Addendum #1

ITT 2025-38

General Contractor Services for Site Improvements at

ÉSC Sainte Trinité, Oakville

Replacement Planting Plan

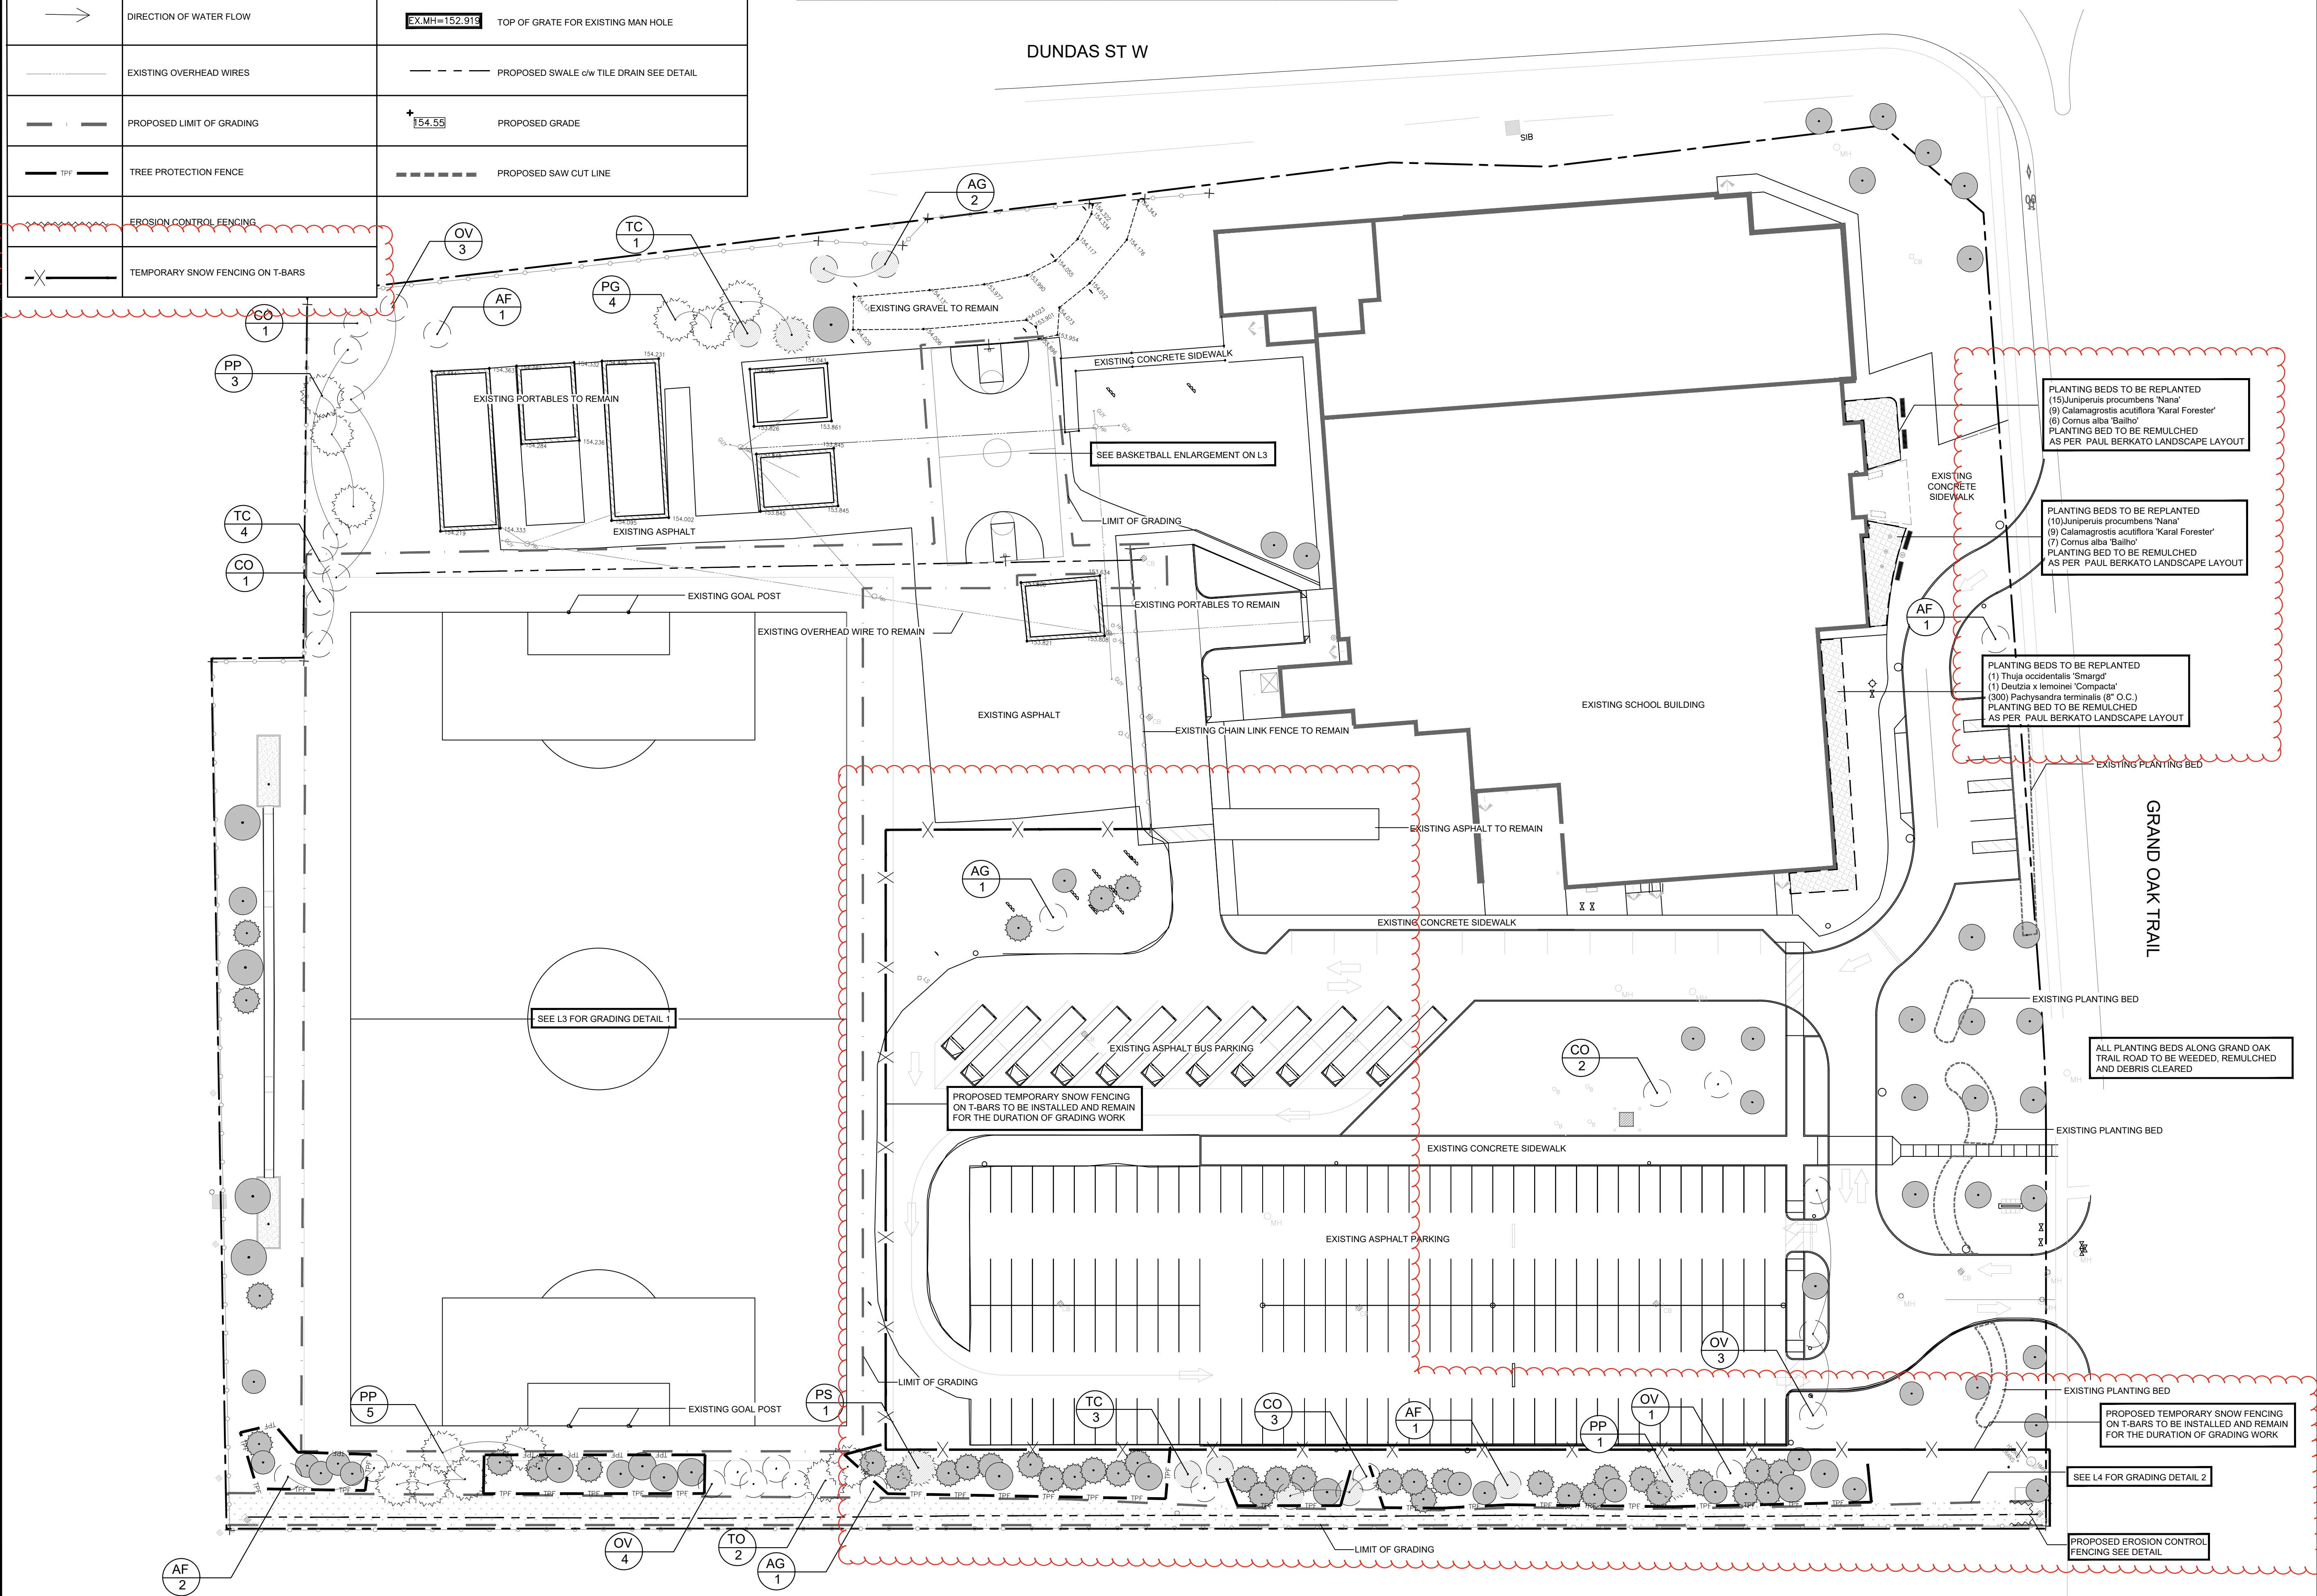
1. **Snow Fence Installation:** added 274 linear meters of snow fence along the parking lot.
2. **Drawing Update:** included a note about watering trucks on Drawing L1.
3. **Screened topsoil/Sod Restoration Adjustment:** modified the topsoil and sod restoration plan to account for an existing asphalt area (469 m²) that was not captured in the original survey.

- NOTES:
- ALL TREES TO BE STAKED WITH WOOD STAKES AND TIED WITH ARBORTIE, OR APPROVED BIODEGRADABLE EQUAL.
 - ALL TREE PITS AND PLANTING BEDS TO RECEIVE 100mm COMPACTED DEPTH MULCH
 - WATERING OF SOD AND PLANTS TO BE BY WATERING TRUCK FOR THE DURATION OF SOD INSTALL
